Change Order

PROJECT (Name and address): Rapid City Utility Maintenance Facility Rapid City, South Dakota	CHANGE ORDER NUMBER: 001 DATE: November 25, 2014	OWNER: <input checked="" type="checkbox"/> ARCHITECT: <input checked="" type="checkbox"/> CONTRACTOR: <input checked="" type="checkbox"/> FIELD: <input type="checkbox"/> OTHER: <input type="checkbox"/>
TO CONTRACTOR (Name and address): SECO Construction, Inc. P.O. Box 2921 Rapid City, SD	ARCHITECT'S PROJECT NUMBER: 13373 CONTRACT DATE: September 17, 2014 CONTRACT FOR: General Construction

Work Changes Proposal Request

B1 UNDERFLOOR PLUMBING PLAN
SCALE: 1/8" = 1'-0"

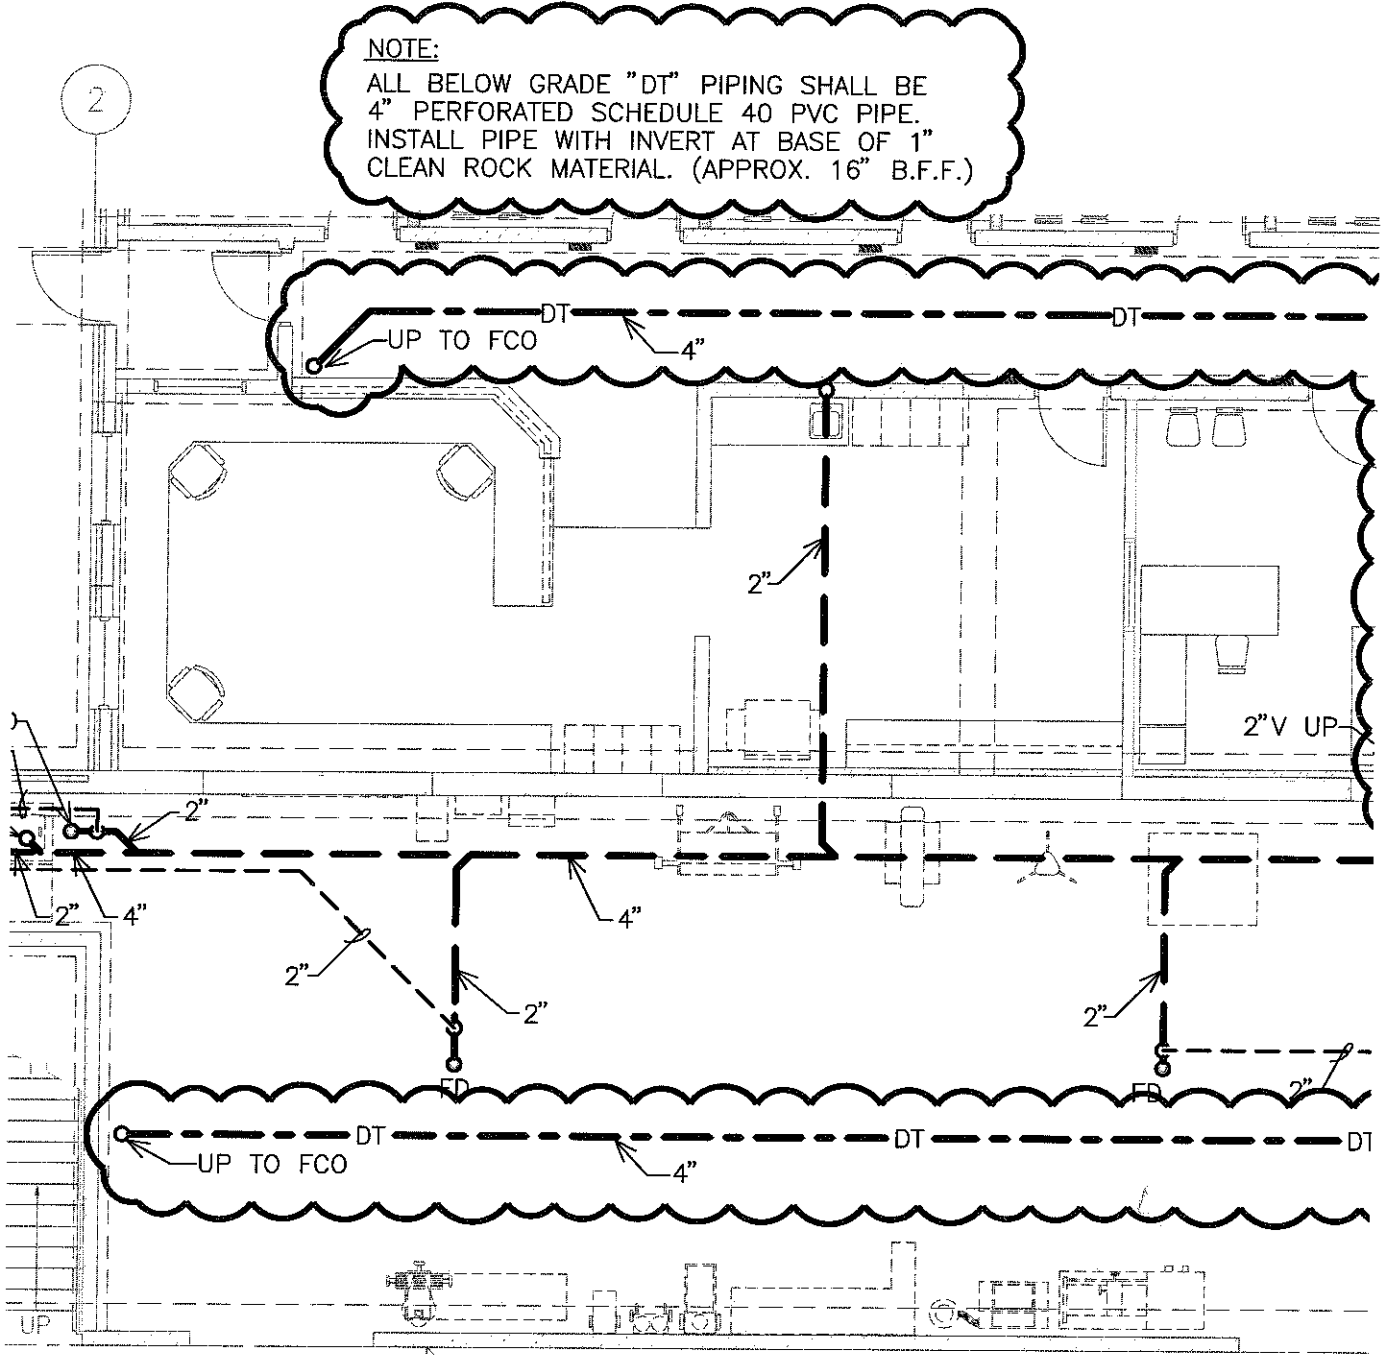
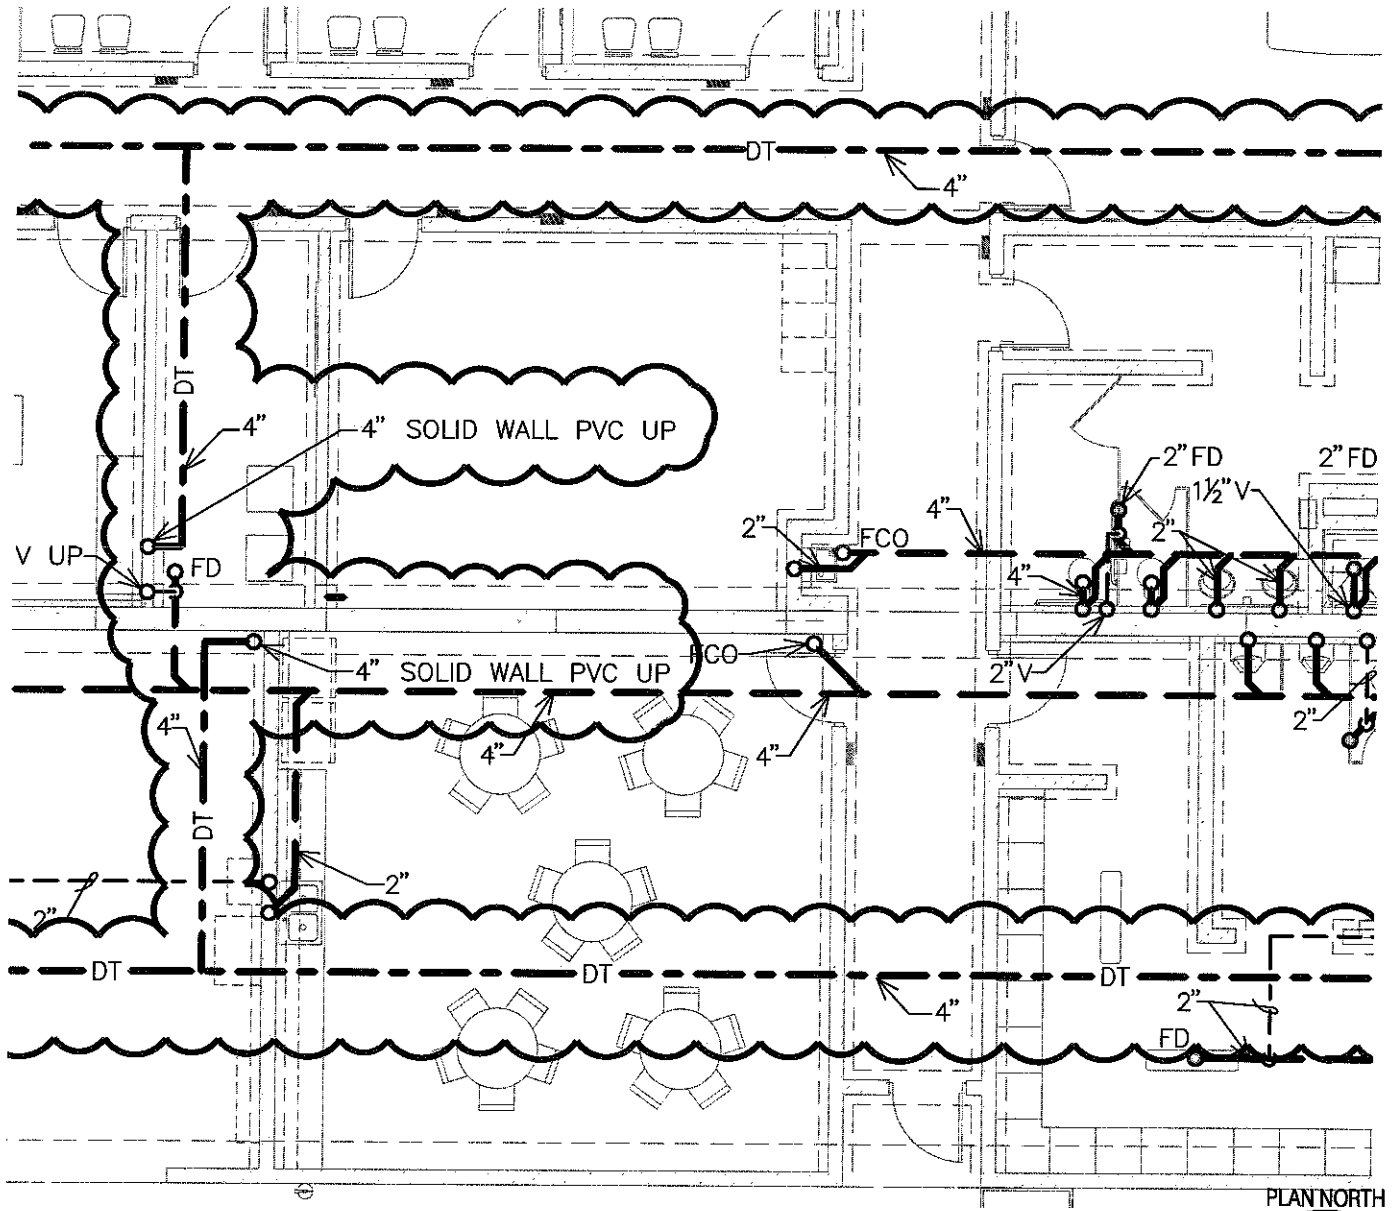
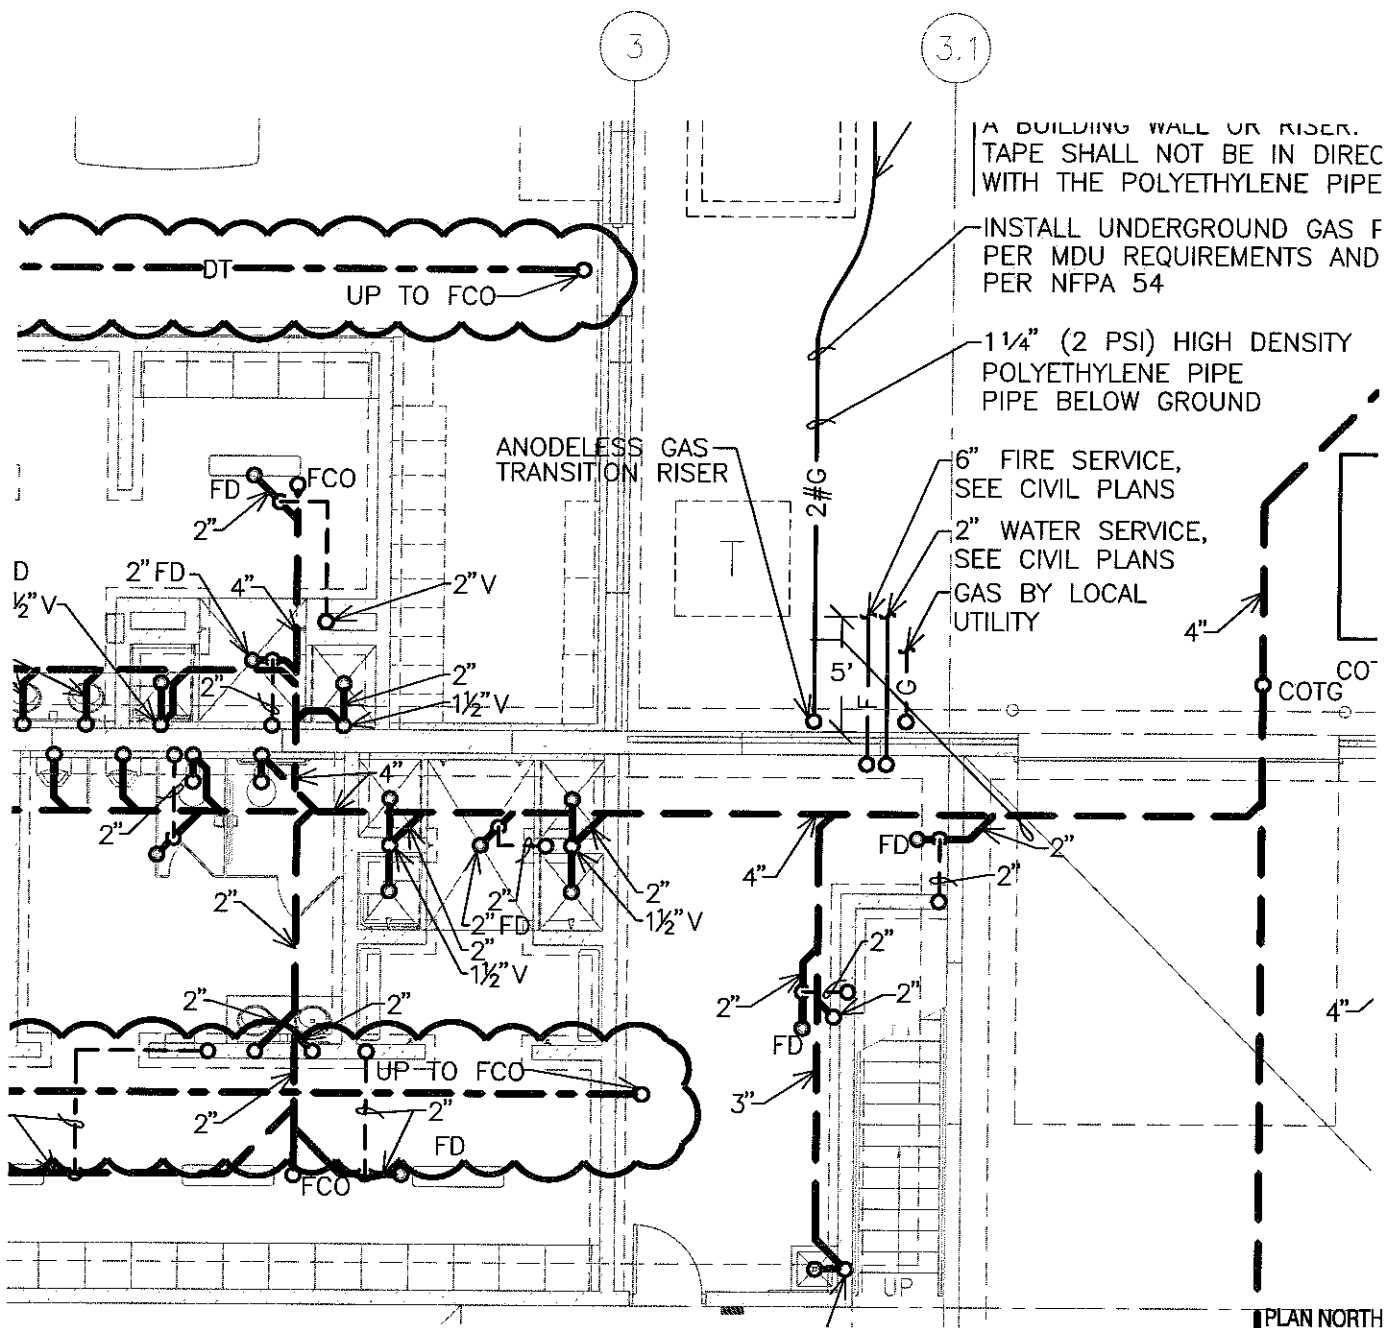
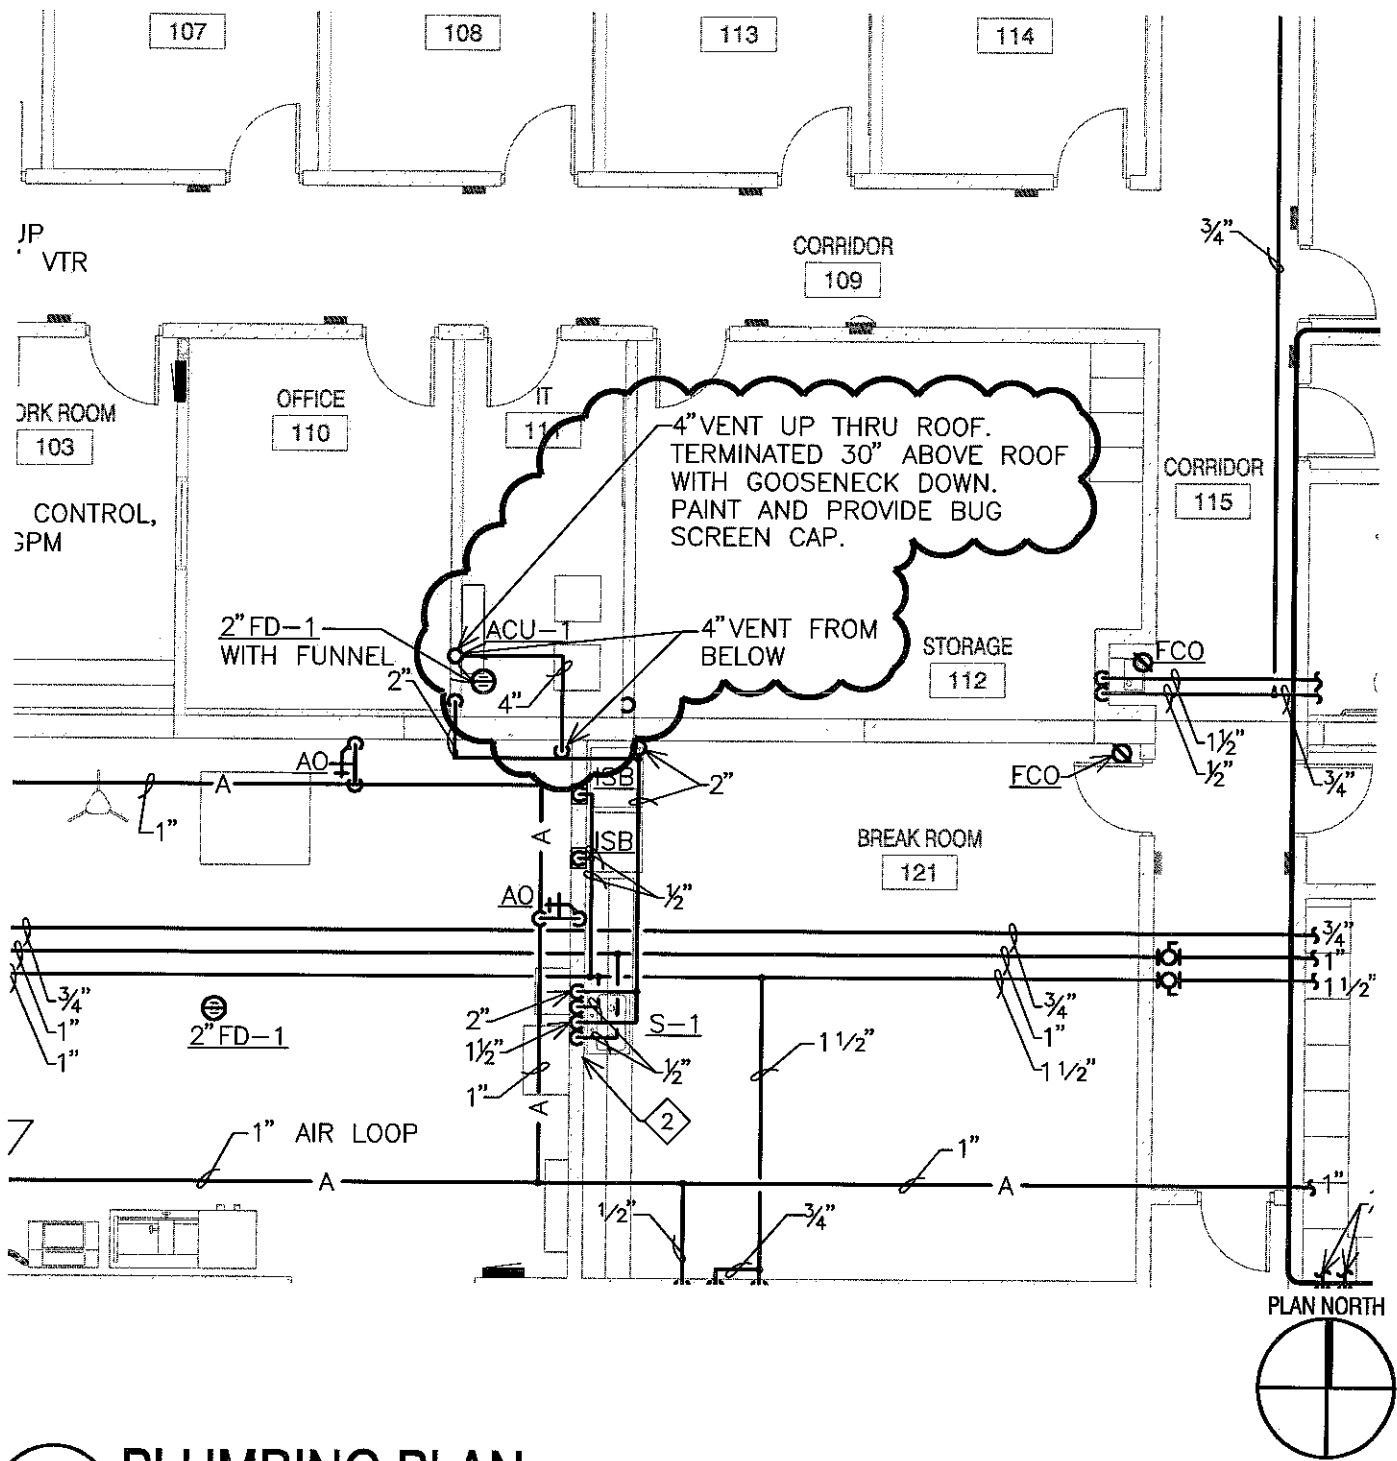
1. Provide 4" Schedule 40 perforated PVC piping below slab and solid wall PVC vent up thru roof as shown on attached sketches MSK4-1, MSK4-2, MSK4-3, MSK4-4. Install 1" clean rock to a depth of 8". Provide and install Vapor Block Plus in lieu of Vapor Block VB6-VB10 previously approved. Modification is required to alleviate possible VOC migration due to contaminated soils in the area of occupied spaces.

ALL BELOW GRADE "DT" PIPING SHALL BE 4" PERFORATED SCHEDULE 40 PVC PIPE. INSTALL PIPE WITH INVERT AT BASE OF 1" CLEAN ROCK MATERIAL. (APPROX. 16" B.F.F.)
